STATE OF NORTH CAROLINA
DEPARTMENT OF TRANSPORTATION

Subject: **Modification of Section 404 Nationwide Permits 23 & 33, and Section 401 Water Quality Certification** for the proposed replacement of Bridge Nos. 140 & 147 over Mallard Creek on US 29 in Mecklenburg County, Federal Aid Project No. BRSTP-29(39), Division 10, TIP No. B-4779, Debit \$570 from WBS 38550.1.1.

Reference: Section 404 Nationwide 13, 23 and 33 Permit, Action ID 2012-00782 issued June 6, 2013.
Section 401 Water Quality Certification, DWQ No. 13-0553, issued June 11, 2013.

PROJECT REFERENCE NO. B-4779	SHEET NO. 4
RW SHEET NO.	
ROADWAY DESIGN ENGINEER	HYDRAULICS ENGINEER
PRELIMINARY PLANS DO NOT USE FOR CONSTRUCTION	
Revised	Sept 2013
PERMIT DRAWINGS SHEET 2 OF 6

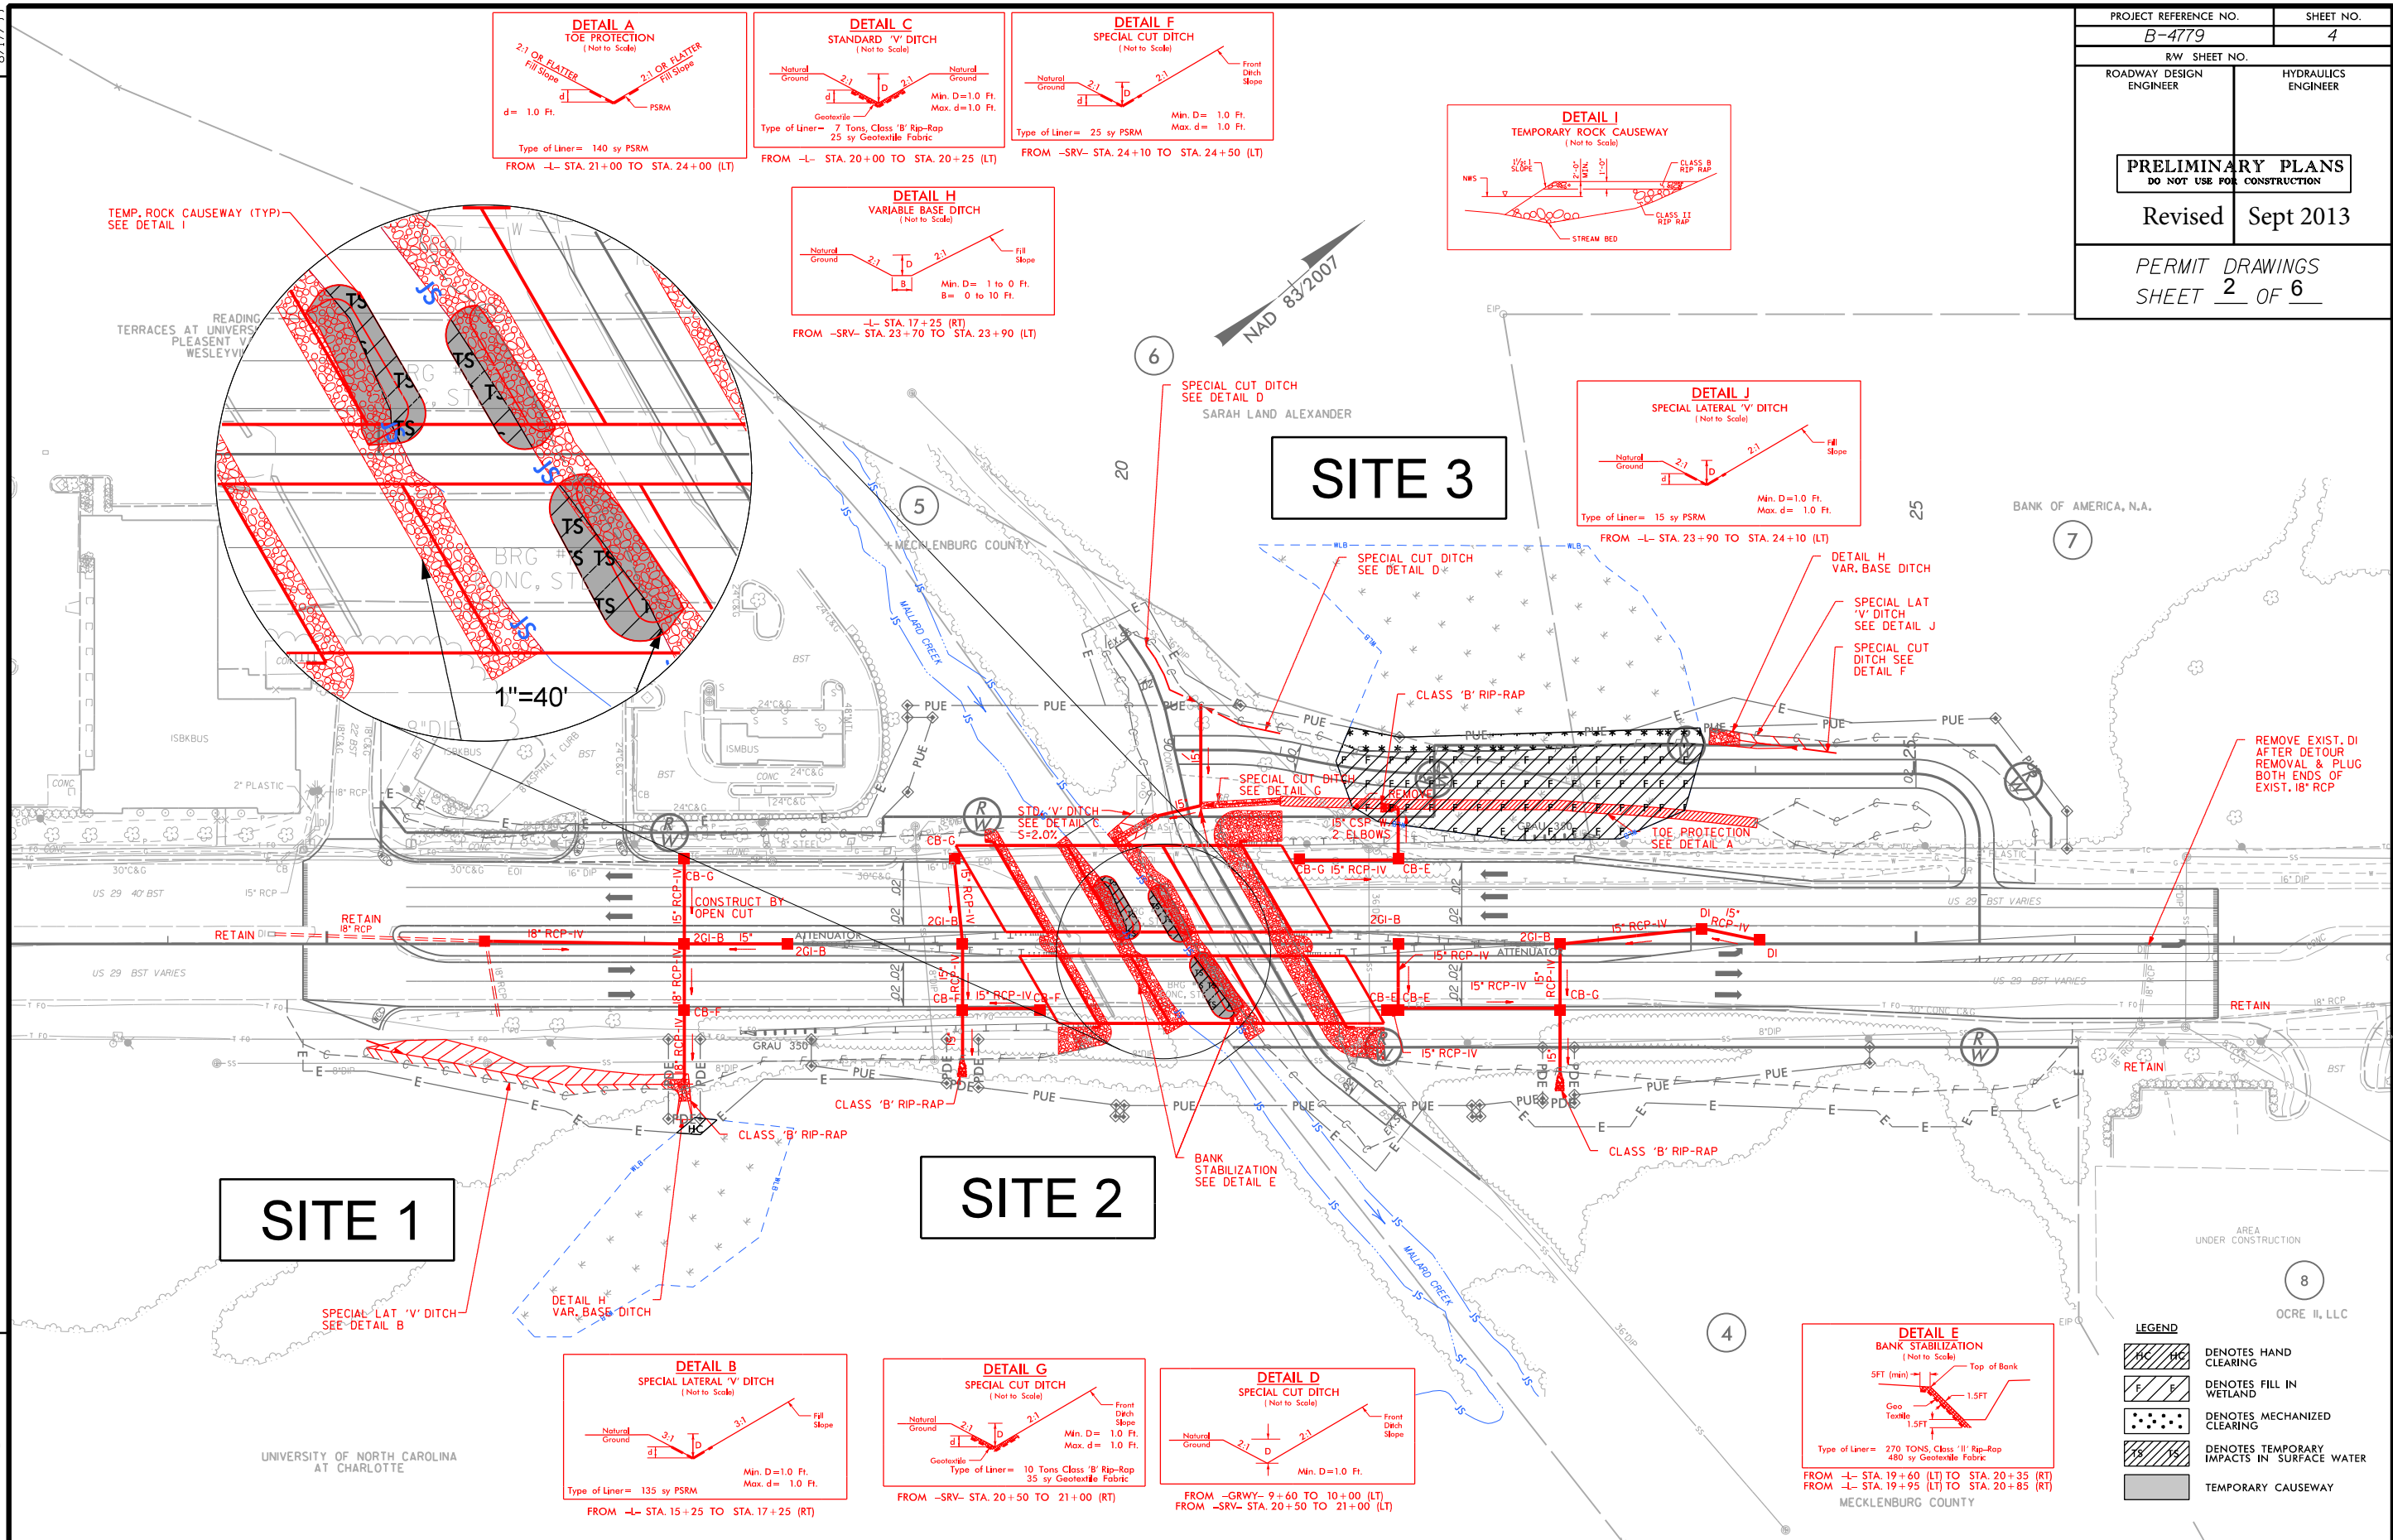
A temporary work pad has been eliminated. This change reduces temporary impacts to Mallard Creek from 0.03 acre to 0.02 acre.

PROJECT REFERENCE NO. B-4779		SHEET NO. 4	
RW SHEET NO.			
ROADWAY DESIGN ENGINEER		HYDRAULICS ENGINEER	
PRELIMINARY PLANS DO NOT USE FOR CONSTRUCTION			
Revised		Sept 2013	
PERMIT DRAWINGS SHEET 3 OF 6

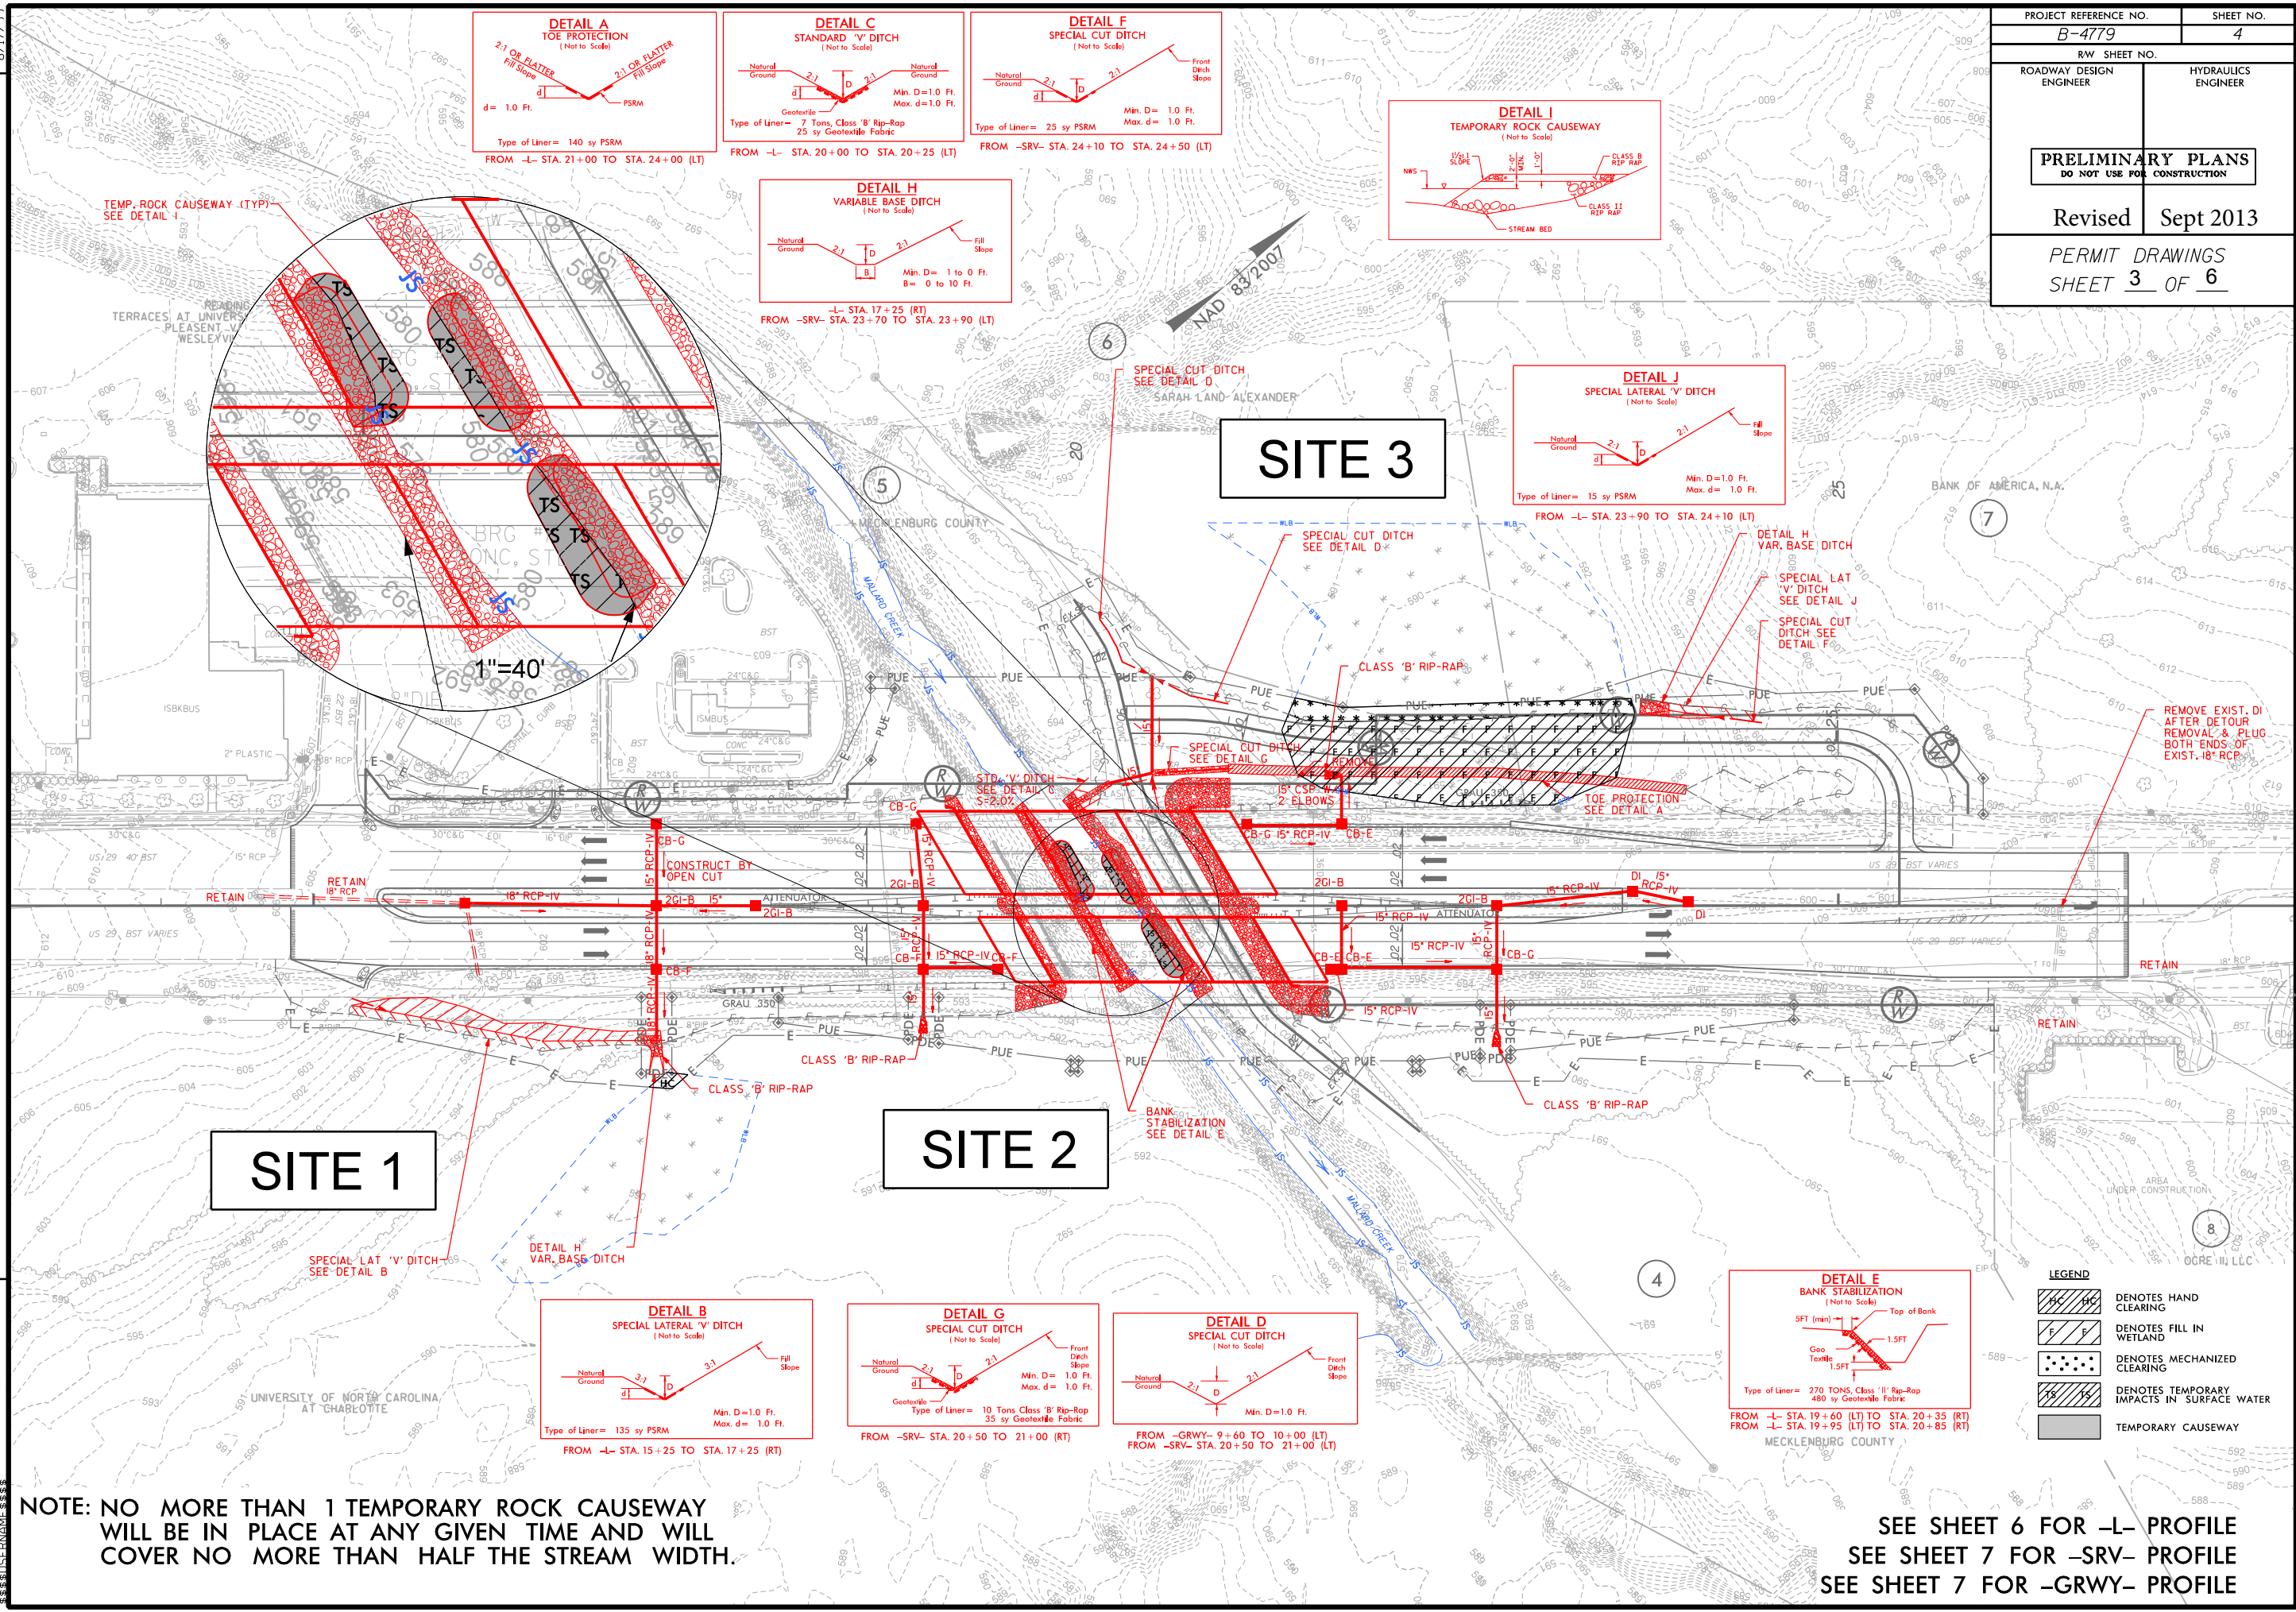
Due to safety concerns with the previous design in regard to pedestrian traffic from the multi-use greenway path under the bridge, the design has been modified to allow pedestrians to safely detour around the work area. The revised design places pedestrians on the service/emergency access road and away from construction activities. This reduces the construction staging area and removes the construction equipment/ pedestrian conflict. However, this shift will result in a net increase in permanent wetland impact of 0.04 acre at Site 3, by way of an additional of 0.06 acre of permanent fill and a reduction of 0.02 acre of mechanized clearing.
